## **Agenda Update Sheet**

### **Planning Committee**

### **Application DM/18/4541**

Updated comments from Balcombe Parish Council, received 14 October 2019:

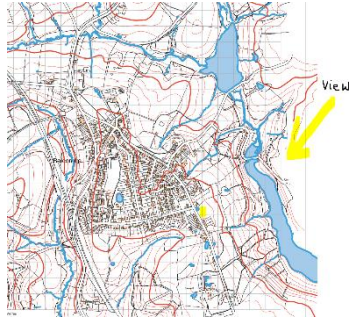
**Pedestrian access** across Haywards Heath Road onto the existing footway on the west side of HH Road remains a concern. With speeds of between 35 and 50 mph recorded and low standard sightlines this is hazardous. BPC would like to see a pedestrian island provided. This will require a localised widening of the carriageway by 1.2m eastwards at the site entrance. This would also act to slow traffic. There are pedestrian crossings at other locations in the village with slower speeds and less traffic, installed when Junction 10a was opened. They are sited at the crossings closest to the entrances to the village where speeds are high, just like this one. One wasn't needed at this location before, as there was nothing to cross to.

BPC's concern remains, no island is being provided. Although the WSCC Highways Officer has not ruled out her agreement to such a crossing, noting that it could be provided as part of a subsequent traffic calming scheme, she has not made it a requirement of the development. This is regrettable.

It should be noted that once the access to the site has been constructed there will be little scope for retrofitting a crossing or for developing a traffic calming scheme on this length of road.
